# **PRODUCT CHANGE NOTICE**

## **Shipping Tube Change for Intersil MSOP Packaged Products**

**Refer to:  
PCN11059**

**Date: June 17, 2011**

### Current – Round Profile

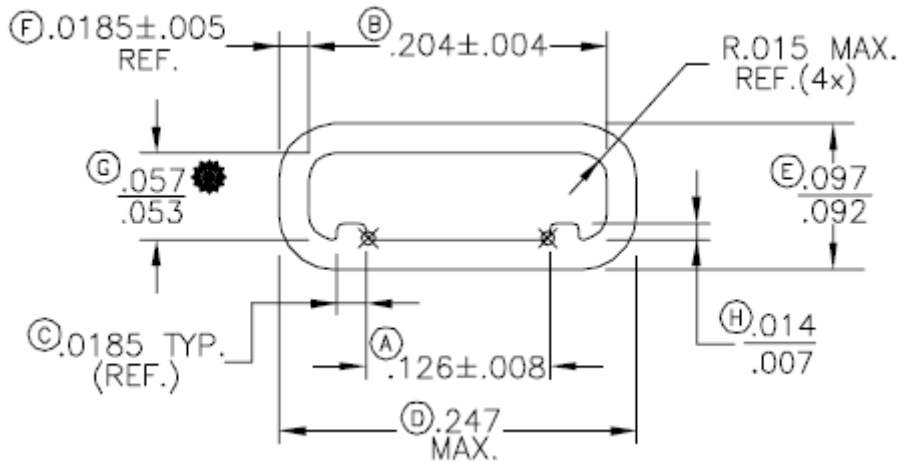
This notice is to inform you that Intersil is changing the anti-static tube used for packing/shipping of MSOP (Mini Small Outline Plastic) packaged products from the Carsem, STATS ChipPAC, and Unisem facilities located in Malaysia. The change from a round profile (current) tube to a rectangular / square profile (new) tube will eliminate lead contact with the tube body thereby reducing the potential for bent leads.

The industry standard tubes are made of an anti-static material. There will be no change in tube length or the quantity of units packed in a tube. Dimensional information and drawings of each type are included on the next page for reference.
